PLANNING APPLICATION FP/46/19/PL- PROPOSED EXTENTION AND ALTERATIONS AT 28 SEA DRIVE

ANNEX A & B- SHOWING AREAS OF DISCREPENCY WITHIN THE PLANNING APPLICATION FP/46/19/PL

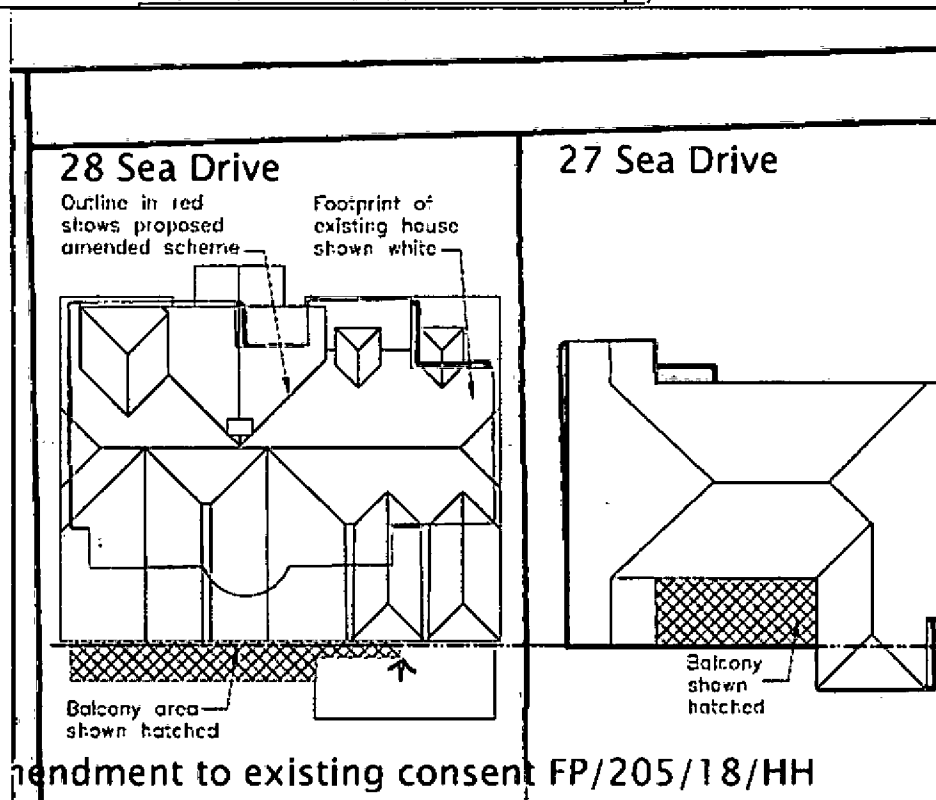
Concerns relating to my rights of privacy

- 1) The balcony reaches over very close to my boundary, even with an obscured glass screen, will erode my privacy at the back of my house, kitchen and patio. Also my very secluded balcony will be on view from the proposed balcony.
- 2) I am worried the proposed balcony might be widened over the single storey which runs down the side of my garden, past my patio, as the living area of no 28 is on the first floor.
- 3) There is a very odd placement of the two first floor patio doors leading to balcony on the single storey. They are not placed centrally under the pitched roof. I fear if they were moved centrally under the pitched roof — certainly more aesthetically pleasing — they would further impinge on my privacy, being too close to my boundary.

I feel this building is overbearing
